CITY OF WEST LAKE HILLS, TEXAS
NOTICE OF BOARD OF ADJUSTMENT (BOA) REGULAR MEETING
Wednesday, January 13, 2021 at 7:00 PM

4. **Land Use 809 Canyon Creek:** Discuss and Consider Action on Several Variance Requests in Order to Rehabilitate/Remodel an Existing Home that is Non-Conforming:

RE: Permit No. 15737 809 Canyon Creek Drainage Plan – Review 5

809 CANYON CREEK
DRAINAGE ANALYSIS
DRAINAGE AREA MAP
SHEET 1

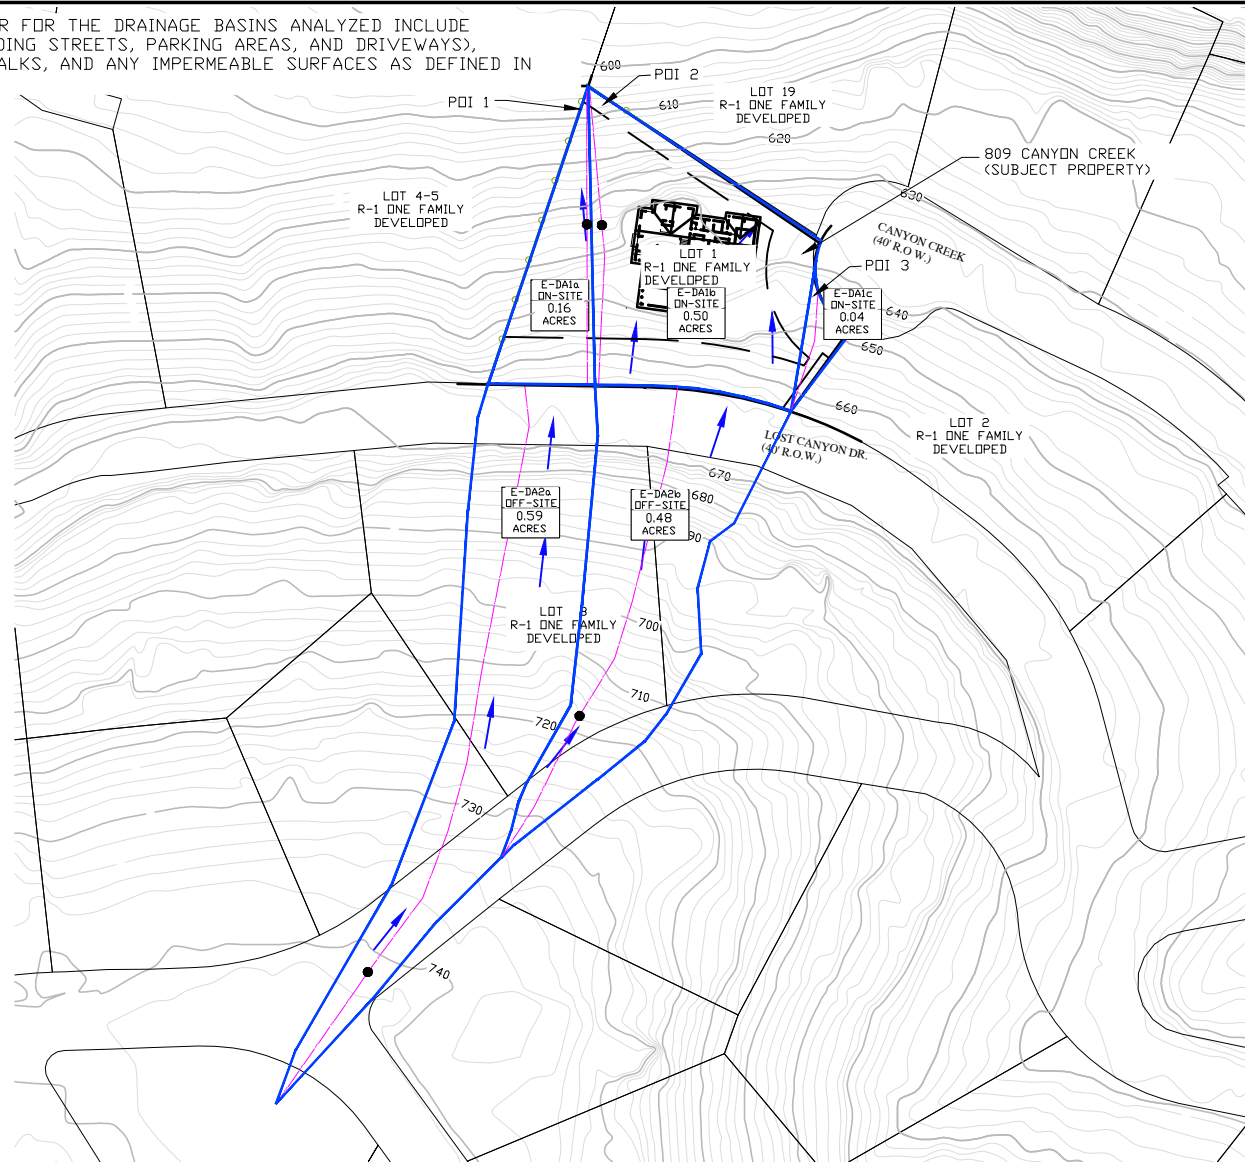
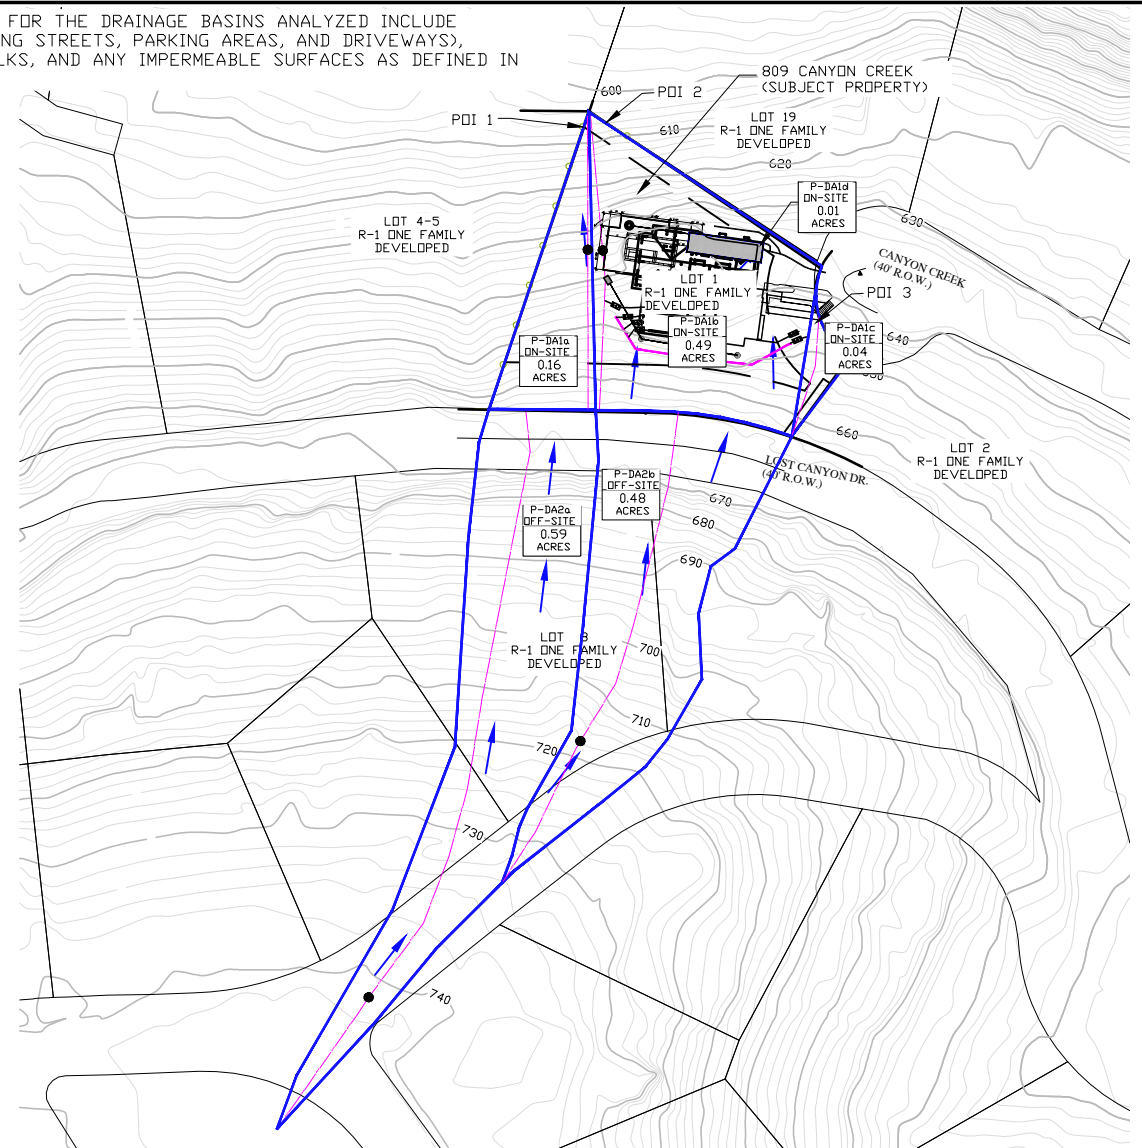
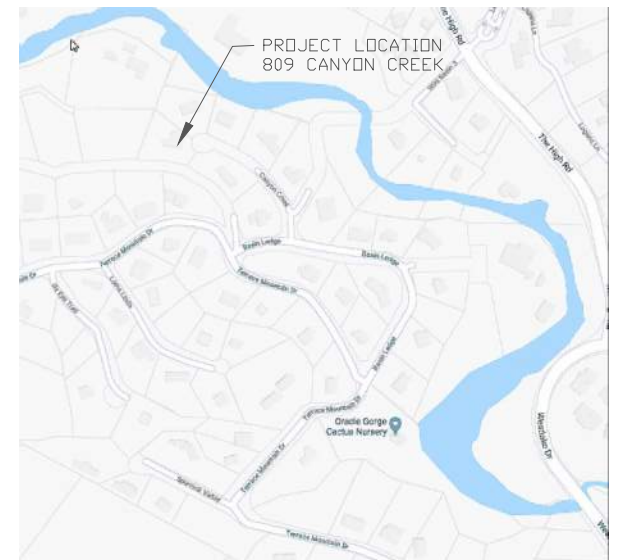
1. Please verify drainage areas are labeled correctly in the proposed drainage area map. The labels don't match what is shown in the table or in the HEC-HMs Model layout for Existing and Proposed Conditions.

2-R1) The drainage map (SHEET 1) and table shown in calculation sheet (SHEET 3) have been updated and now match.

809 CANYON CREEK
DRAINAGE IMPROVEMENT PLAN
ON-SITE DRAINAGE PLAN
& SOIL EROSION CONTROL
SHEET 2

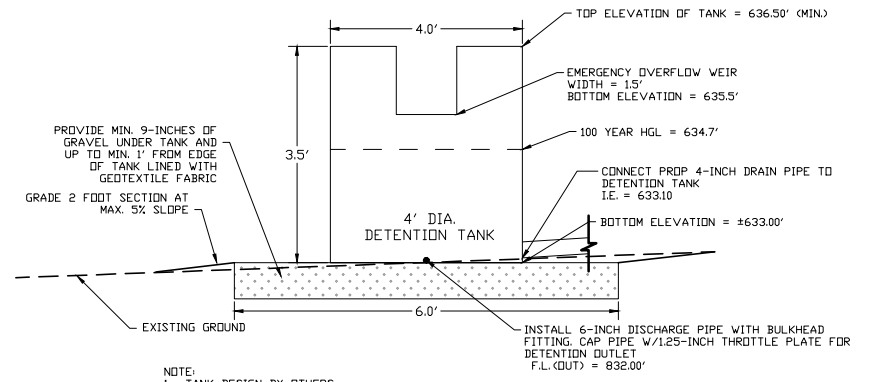
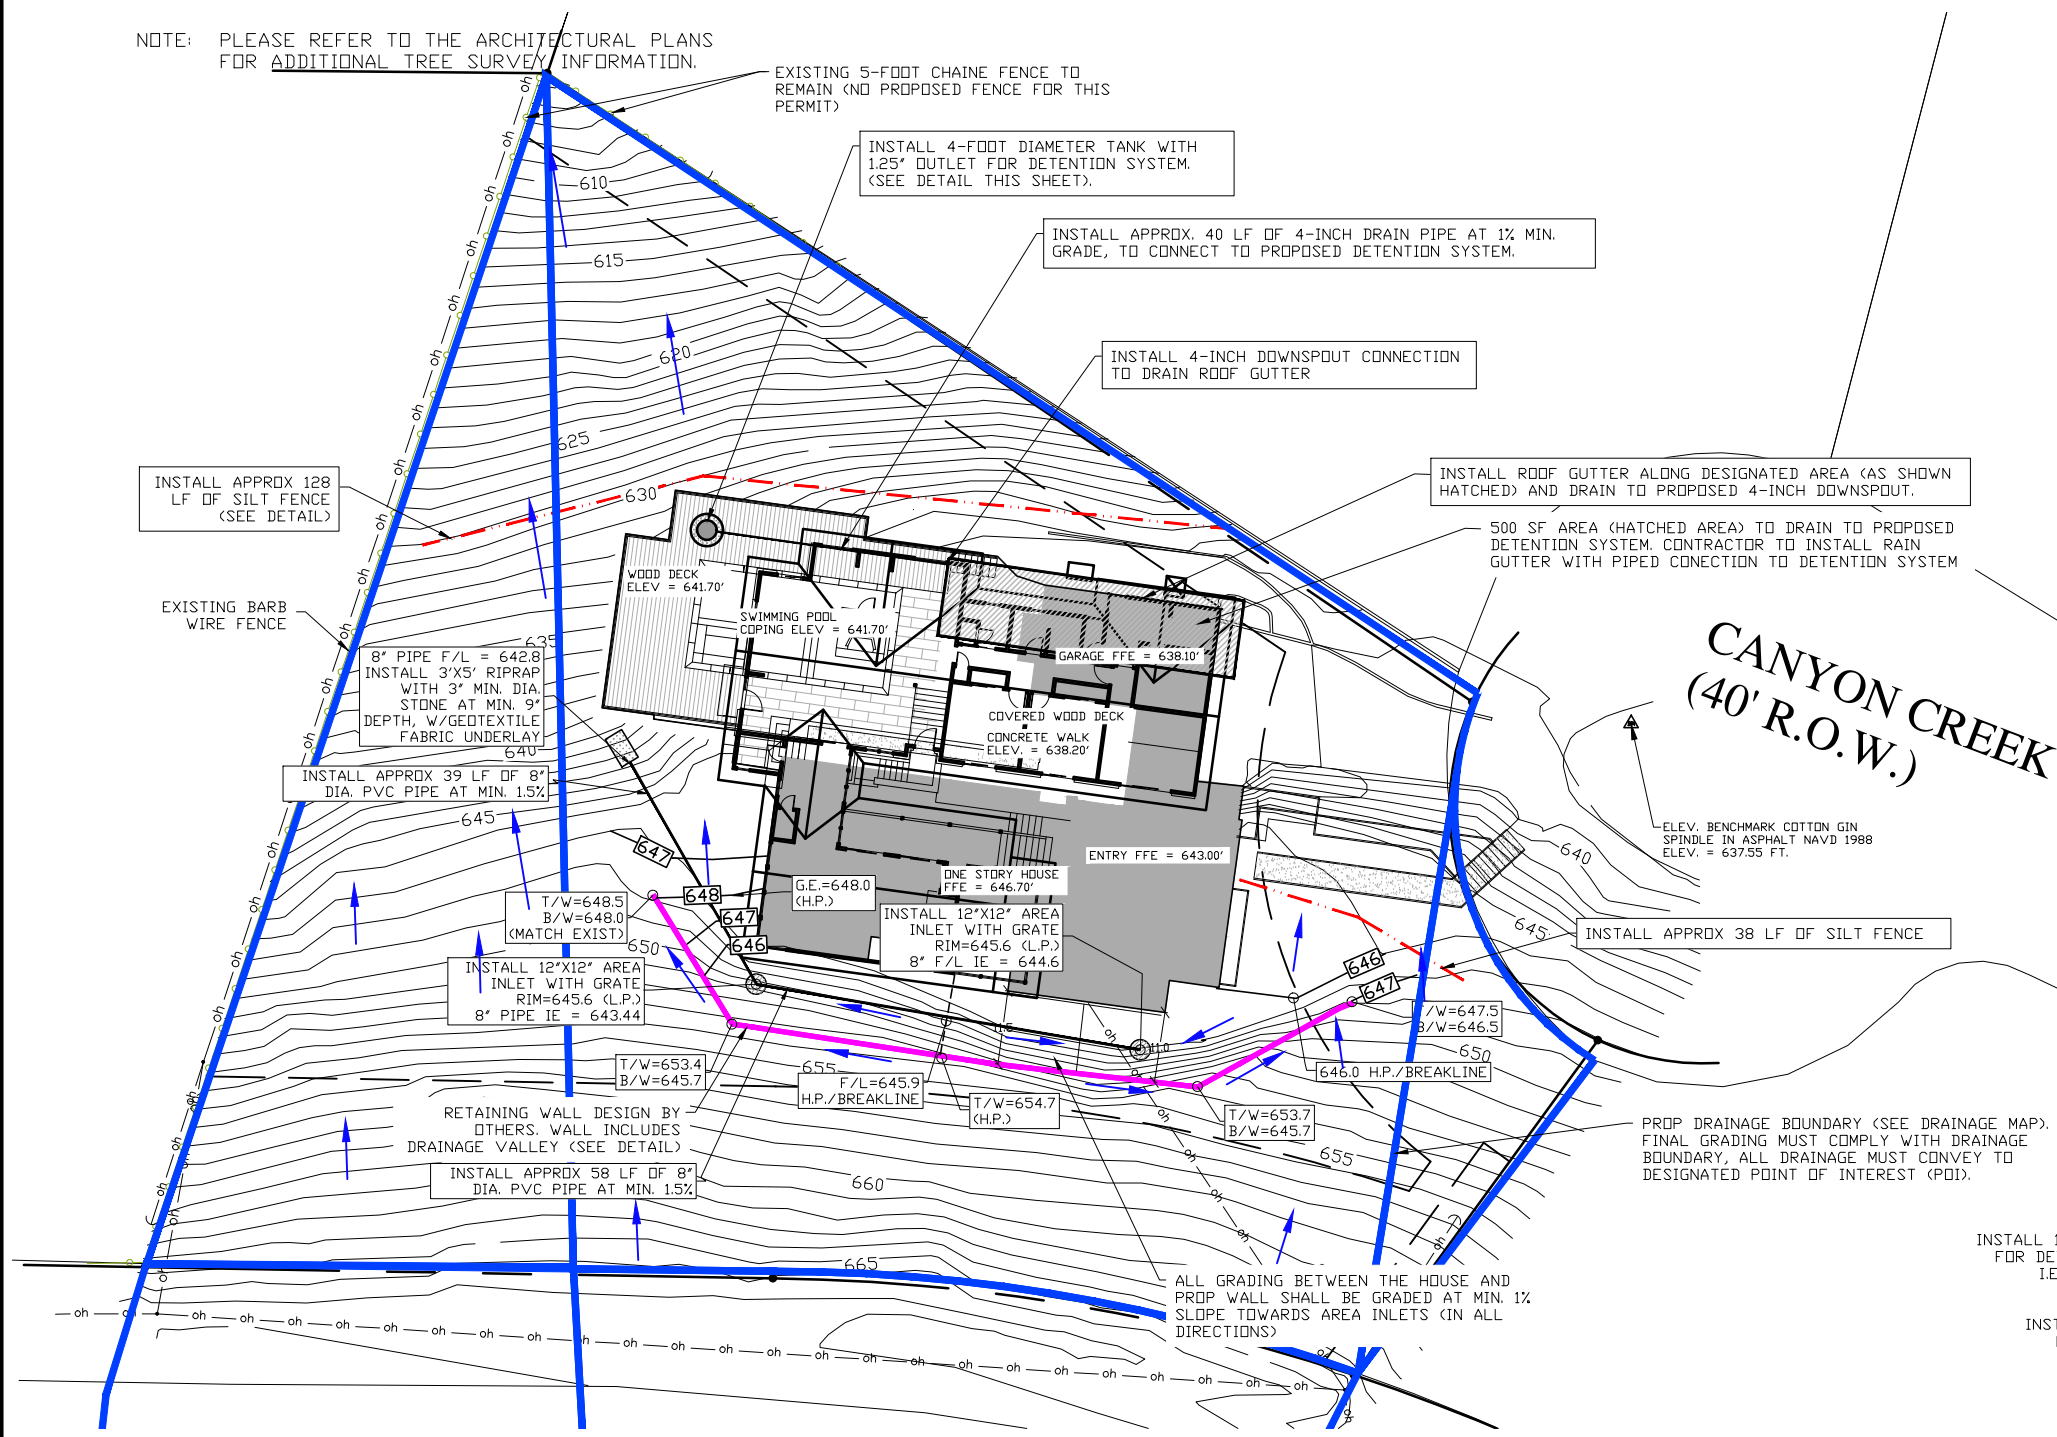
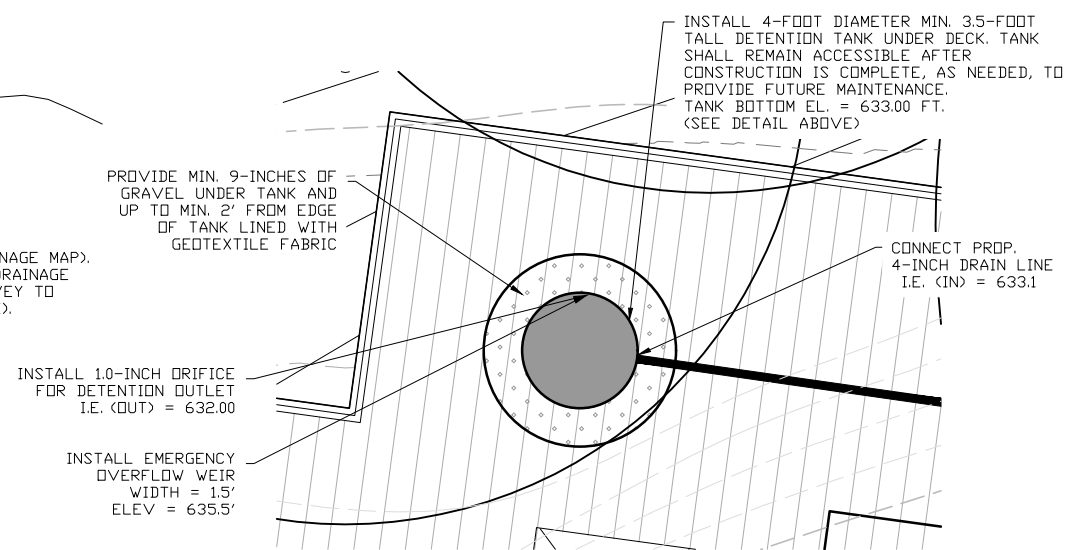
2. Provide the location of all existing and proposed fences including the type of fence.
2-R1) Existing fence demonstrated and labeled on Sheet 2, no proposed fence.
2-C1) Cleared.

3. Please provide spot elevations and finished floor elevations for the proposed structures, slabs, driveways, porches, patios, pools and outbuildings on all sides. Finished grades are required to be sloped to direct stormwater away from the structures.
3-R1) Sheet 2 provides spot elevations and grading plans.
3-C1) Cleared.

6. Rainwater harvesting is not an approved detention method for the City of West Lake Hills. Please provide proper stormwater mitigation.

7. Per the West Lake Hills Drainage and Erosion Control Design Manual Sec. 5.1(g), detention ponds shall be designed with an outlet structure to allow safe passage of the 100-year post-development design storm runoff. Provide calculations for the outlet structure and emergency spillway showing compliance.

7-C1) **Please provide calculations for the appropriate sizing of the overflow spillway.**

7-C2) **Please revise detention system detail on sheet 2. Only the callouts are shown. Please provide calculations or HEC-HMS output for emergency overflow spillway.**

8. Provide the 100-year WSEL for the pond and indicate the freeboard. Freeboard of at least 1.0 foot within the pond must be provided per West Lake Hills Drainage and Erosion Control Design Manual Sec. 5.1(p).

6-R1) *Note that the proposed conditions do not exceed 20% IC and rainwater harvesting is not proposed for this permit. The collection system is intended for detention purposes only. Adjustments have been made to Sheet 2 for clarity.*

7-R1) *See Sheet 2 for proposed detention pond plan. Note that a 4-foot diameter tank is identified for detention purposes and will not be used for water quality or any other purpose other than providing detention needed to comply with WLH drainage requirements. Calculations are provided on sheet 3.*

7-R2) *Spillway has been added to detention system. HEC-HMS was used to analyze/size pond, outlet, and emergency overflow spillway.*

7-R3) *Sheet 2 has been updated for cross-sectional detail. Calculation for the pond along with elevations demonstrated for each storm event, are shown on Sheet 3.*

8-R1) *Calculations and details are provided on Sheet 3 and include the required 1 foot freeboard. Sheet 2 provide a cross sectional detail of the detention pond with the 100 year WSEL freeboard demonstrated.*

809 CANYON CREEK
DRAINAGE IMPROVEMENT PLAN
CALCULATIONS & DETAILS
SHEET 3

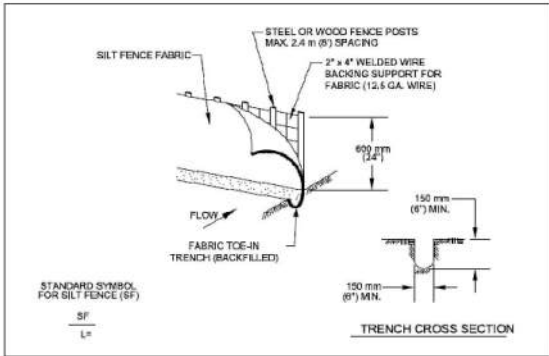
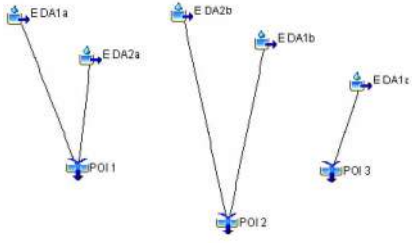
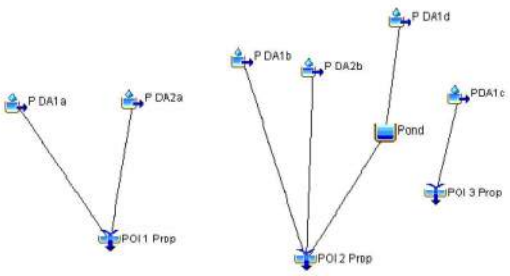
5. Verify the sheet flow calculations as it appears the manning's "n" coefficients for DA E1 and DA P1 are inconsistent with the West Lake Hills Drainage and Erosion Control Design Manual Table 3-5.

5-C1) **Please verify manning coefficient used for the offsite drainage areas. The coefficient 0.24 is used which corresponds to dense grass, however the first 100 feet of flow appear to be on a roadway.**

9. Per the West Lake Hills Drainage and Erosion Control Design Manual Sec. 5.3, provide the stage, storage, and discharge summary table for the 2-year, 10-year, 25-year, and 100-year storm events.

5-R1) *Manning's Coefficients are shown on Sheet 3 and comply with WLH D&EC Design Manual.*

5-R2) *Calculations are updated, see Sheet 3.*

9-R1) *The required table is provided on Sheet 3.*

809 CANYON CREEK
DRAINAGE ANALYSIS
DRAINAGE PLAN
SHEET 4

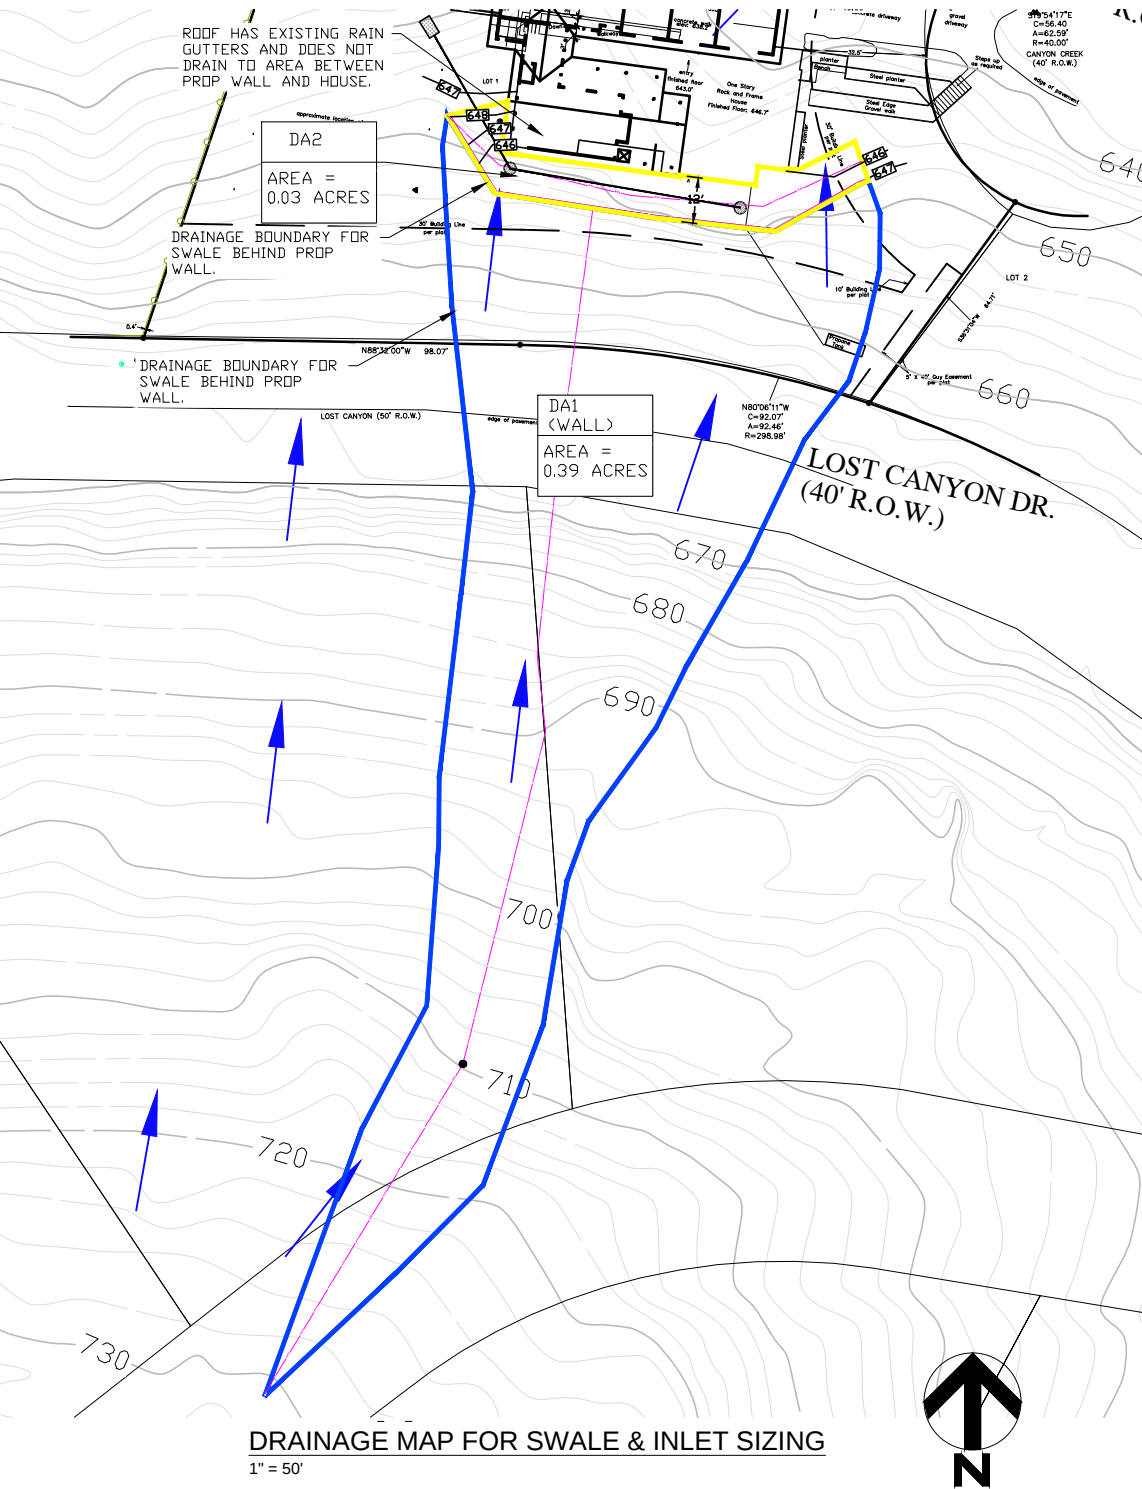
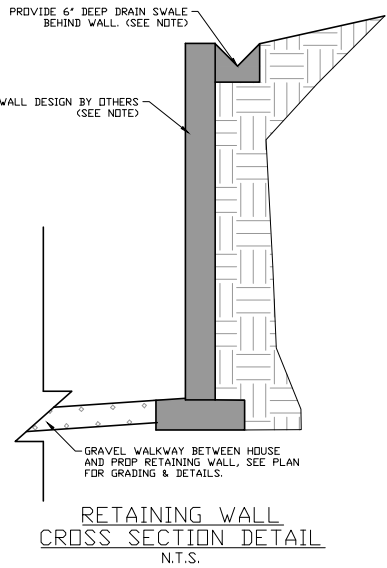
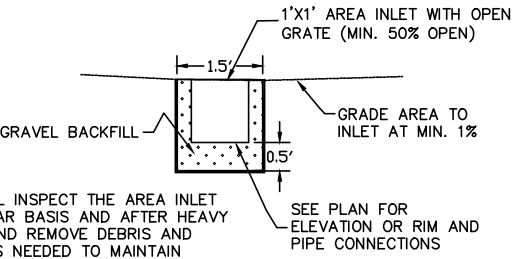
2. Please verify the lag time calculations for the onsite drainage is correct if the minimum time of concentration used is 10 minutes.

2. The plans and drainage report indicate there is a swale upstream of the wall and indicate there is a detail. No detail is shown in the plans.

2-R1) *Lag time have been revised as directed and updated values are used with the HEC-HMS analysis. See Sheet 4 for updated tables, calculations, and HMS results.*

2-R1) The detail for the retaining wall has been added to Sheet 4.
